Field Service Bulletin 26

SBE 49 FastCAT CTD

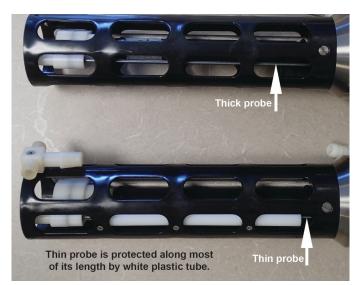
Temperature Sensor Modification for Serial Numbers 0276 - 0320, corresponding to SBE 49s shipped August 2012 - May 2013 (serial numbers approximate; see photo to compare to your SBE 49)

In August 2012 Sea-Bird began using a thinner temperature probe than the previous design (see photo). The thin probe uses the same thermistor resistor component as the thick probe, but the sheath design was modified due to a material change. The change was intended as temporary, until we could reproduce the original sheath with a new material. Although there have not been any reported failures, Sea-Bird returned to the original thick probe design in June 2013.

Sea-Bird returned to the thick temperature probe design in all SBE 49s built after May 2013.
